## S U B M I S S I O N: C A S E Y a written submission by way of objection to DA 2020/1136

Re: 13 Pacific Road Palm Beach NSW 2107 DA 2020/1136

Written Submission: Letter of Objection & Written Submission to NBLPP Submission: Casey

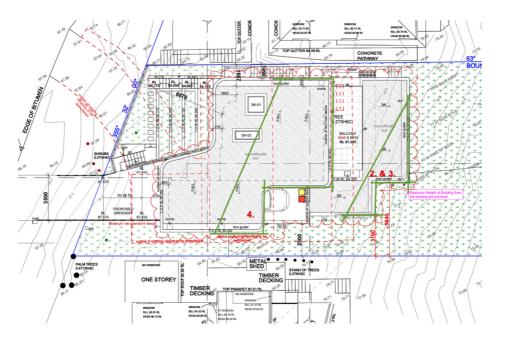
We contend that the excessive height above 8.5m is not 'minor' and fails LEP 4.3 2D [a], and fails the objectives LEP 4.3 [1] [a] desired character of locality, [b] compatible with neighbours, [c] overshadowing, and [d] street view.

Sketch against Roof Plan Rev B: Extensive zones exceed the 8.5m control at both upper levels, shown edged in green on the above sketch. **The area over 8.5m is not 'minor' and fails LEP 4.3 2D [a], and fails the objectives LEP 4.3.** Note that existing and neighbouring dwellings maintain the 8.5m height control.

- o Reduce Building Height not to exceed 8.5m.
- o Compliant Front and Side Setbacks
- o Compliant Building Envelope
- Maintain top of roof to match existing roof height at RL 88.27, and reduce upper-level roof not to exceed the RL 80 contour in alignment to ensure full compliance to standards
- Reduce floor plates below to c. RL 85.1 and c..82.10 and to follow the alignment of proposed ground floor in Rev B drawings
- Maintain existing ramp entry, or a new maximum grade AS ramp using the existing crossover, being the lowest level at the street frontage, with enclosed garaging to the northern side
- o All windows to the South Elevation to have 1.7m sills, and obscured glass or privacy screens.
- o Decks to have 1.7m high privacy screens facing the side boundary
- o Landscaping in southern side setback to proposed wall height

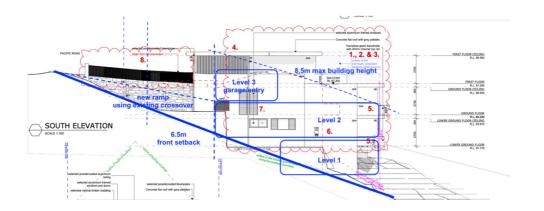
- 1. The extensive zones of the building above 8.5m building height, at the upper two storeys, that will:
- a) be significantly and noticeably higher than existing surrounding development from vantage points below the subject site;
- b) create a jarring and unsympathetic outcome set against neighbouring houses that comply with the 8.5m control;
- c) take public domain street views of the ocean

- d) take winter sun from our north facing windows, and external private open space, refer appendix A, particularly in the zone above the 8.5m building height control;
